ENVIRONMENTAL REVIEW TEAM REPORT

TIMBER TRAILS SHERMAN, CONNECTICUT

NOVEMBER 1978

The Planning and Zoning Commission from the Town of Sherman requested the assistance of the King's Mark Environmental Review Team (ERT) to help the Town in analyzing the two development proposals. The ERT was asked to identify the natural resources of the site and to highlight opportunities and limitations for development. Specific concern of the request include:

FIGURE I

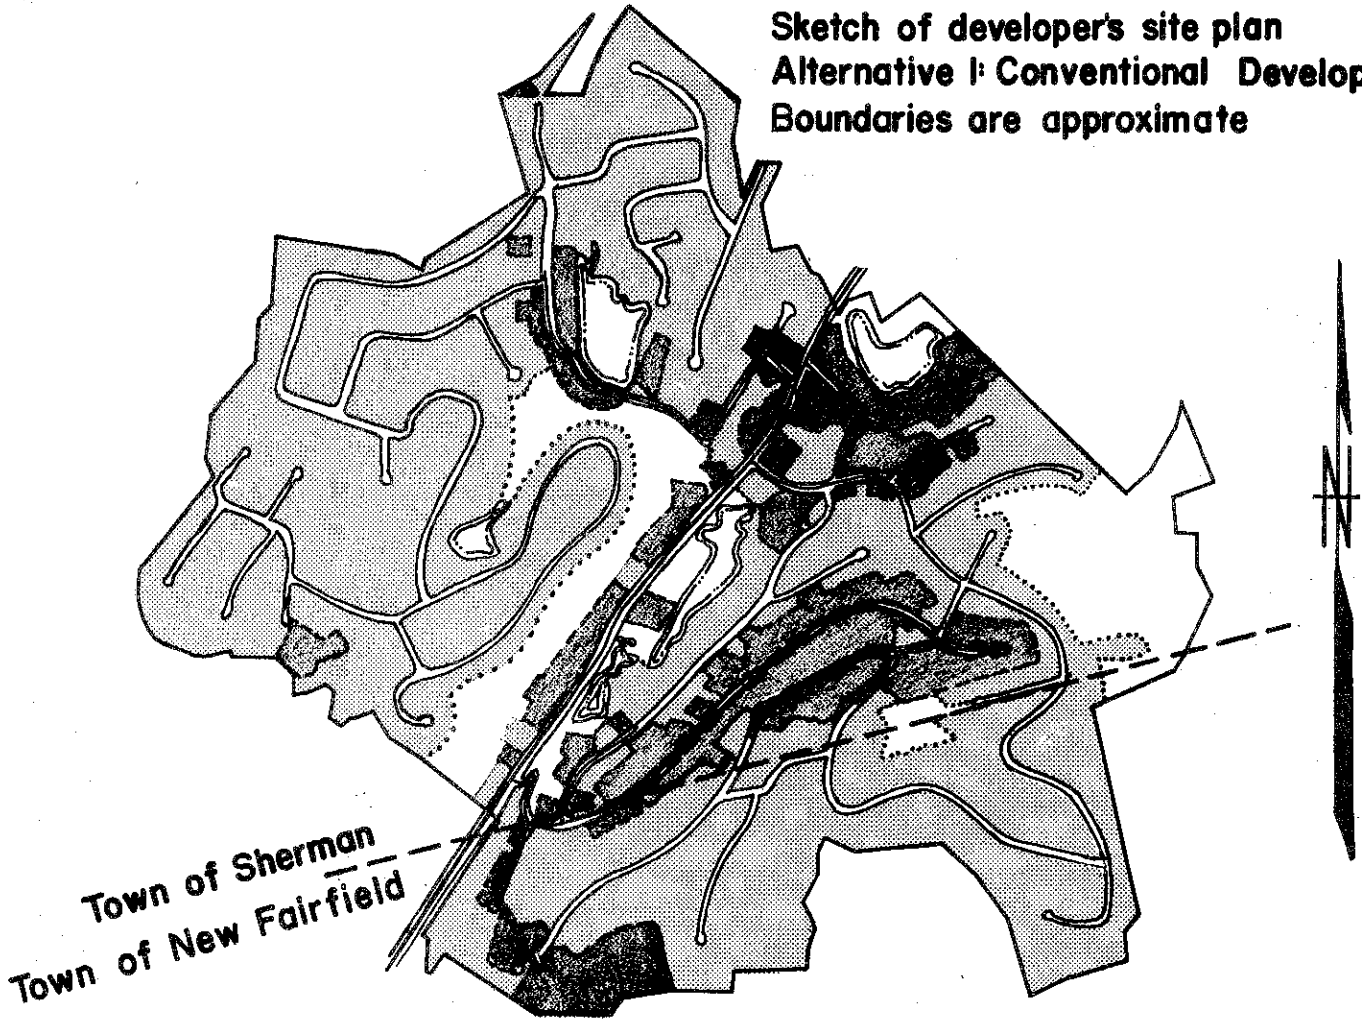
- . The large amount of cutting and filling associated with construction of the proposed roads will make it extremely difficult to provide houses and dwellings at the proposed locations in the conventional plan.

- . Due to the large cuts and fills of the conventional plan and the steep topography of the area, it is suggested that the entire storm drainage system as proposed be carefully reconsidered. Surface water collected along the proposed roads and discharged onto the steep slopes as proposed in the conventional plan would likely cause a serious erosion problem.

One major area of concern is the large amount of cutting and filling associated with construction of the proposed roads. According to site plans, some house lots will be 20-40 feet below or above proposed road grades. To extend cuts and fills at the proposed 2:1 and 3:1 side slopes, the base of the road fill or top of cut will be 50 to 100+ feet. Clearly, to provide a house and driveway at these locations will be extremely difficult.

There are additional problems that the large cuts and fills create in relation to the storm drainage system, water and hydrant lines. Special care is required in laying water and hydrant lines in fill to combat settling and possible rupturing of lines. It is suggested that the entire storm drainage system as proposed be carefully re-considered. Standard headwalls and outlets for culverts should not be used where outlets are on fill and the topography is steep. Surface water collected along the proposed roads and discharged onto the steep slopes as proposed in the conventional plan would likely cause a serious erosion problem. A more preferable plan would be to maintain drainage easements between house lots at selected locations where surface run-off could be carried down via drop manholes to a safe outlet at the base of the slopes. Such a plan would include construction of curbs and gutters with catchbasins along roads to control side slope erosion. Although there is shallow to bedrock soils over much of the area, this will not eliminate the need to carry culvert flow down-slope to a safe outlet. It is also recommended that temporary settling basins be constructed down-slope at pipe outlets to settle out silt, sand, and gravel.

According to page 0 of the developer's conventional plan proposal, ± 226 acres of land would be left in open space (23.5% of parcel). With the exception of the open space proposed in the vicinity of Valley Pond and Deer Pond, the area delineated is characterized by either very steep slopes or wetland soils. It is obvious that opportunities for recreational use would be severely limited in such areas.

FIGURE 2

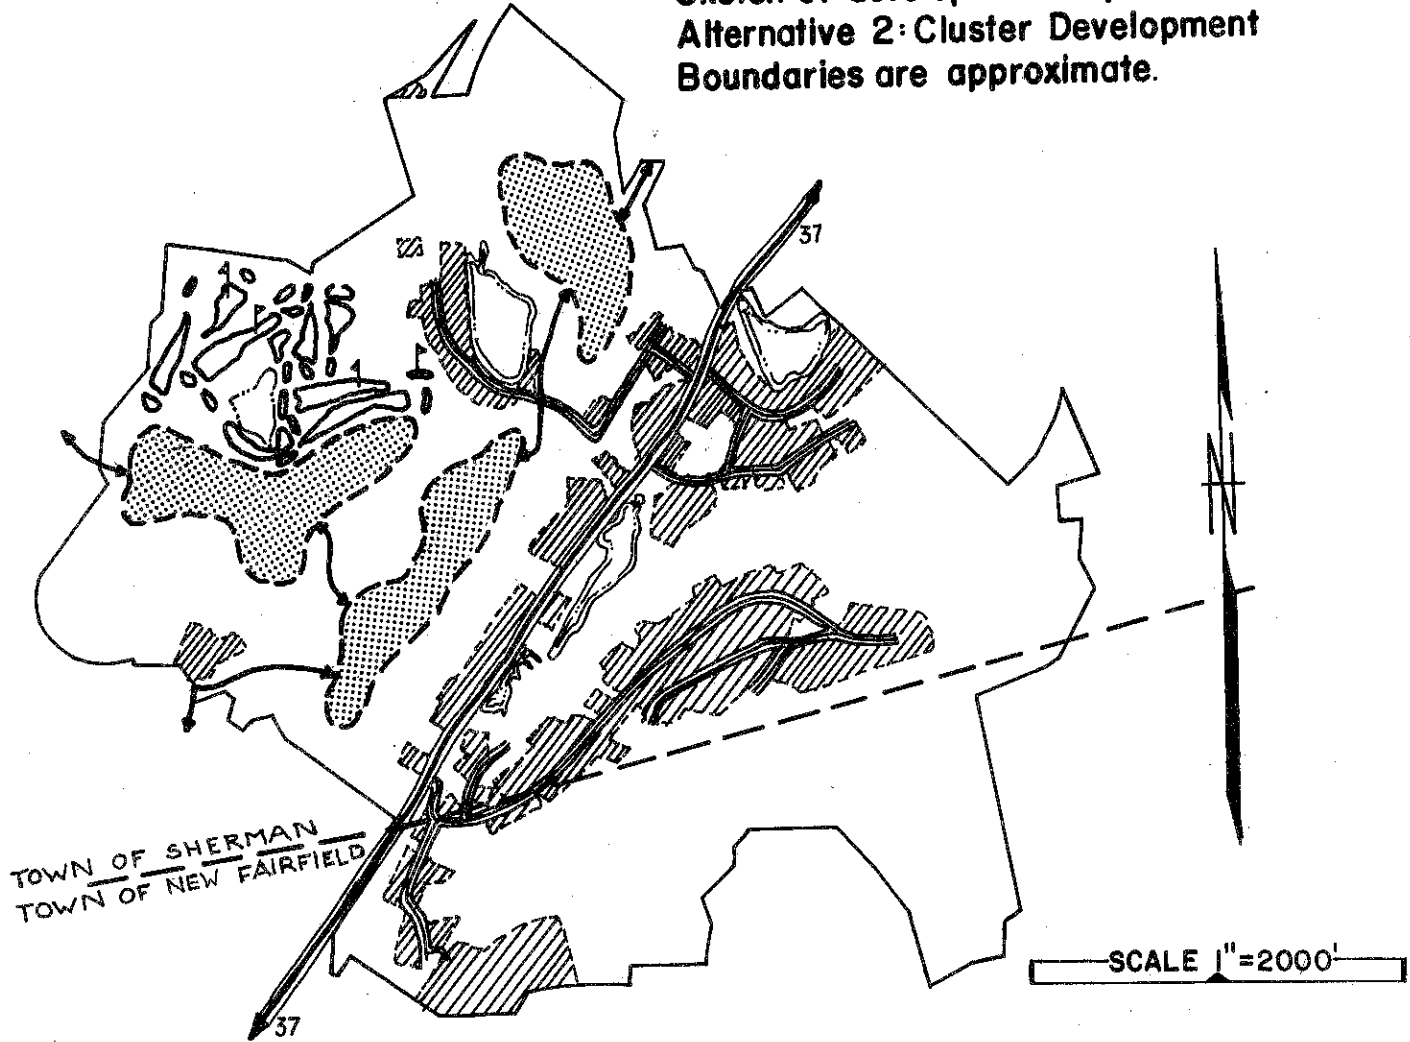
The cluster proposal, as opposed to the conventional proposal, will preserve the equilibrium of more of the site, reduce clearing requirements by half, allow much better environmental control, utilize less restrictive slopes, concentrate the stress within a more manageable area, offer better protection of Quaker Brook, provide better buffering, eliminate post-construction repair costs to the town, and preserve the external aesthetic appearance of the Timber Trails area.

According to the developer, the cluster proposal involves the construction of approximately 900 one and two bedroom rental units to be built in a cluster arrangement, thus requiring a central sewage collection and disposal system. This sewage collection system would consist of conventional gravity sewers, pumping stations, force mains, some type of a secondary sewage treatment plant with the treated effluent to be sprayed in the forest for final disposal. The developer has indicated the area to be used for spray disposal is the + 100 acres of land identified for a golf course on the cluster development plan. This area consists primarily of Hollis-Charlton rocky complex soils of 3 to 15 percent slope. The area is bordered by Hollis-Charlton rocky complex soils of 15 to 35 percent slope, Hollis extremely rocky fine sandy loam 3 to 15 percent slope and to a lesser extent Leicester, Ridgebury-Whitman fine sandy loam. In general, the soils are well drained and limitations with respect to sewage disposal are caused by rocks and boulders, shallowness to bedrock and slope. The Leicester soils have a high groundwater table which is their limiting factor.

The surface broadcast sewage disposal system which has been proposed has not been widely tested for long time periods; hence ecosystem response to this type of input is not well understood. According to a series of EPA seminar publications* the proposed irrigation process has the following characteristics:

The conceptual plan for the cluster development indicates an area in the northwestern portion of the parcel earmarked for a golf course. It should be pointed out however that the developer indicated on the day of the ERT field review that this golf course would probably not be built with implementation of the cluster proposal as this area would be needed for the land spread sewage treatment plant.
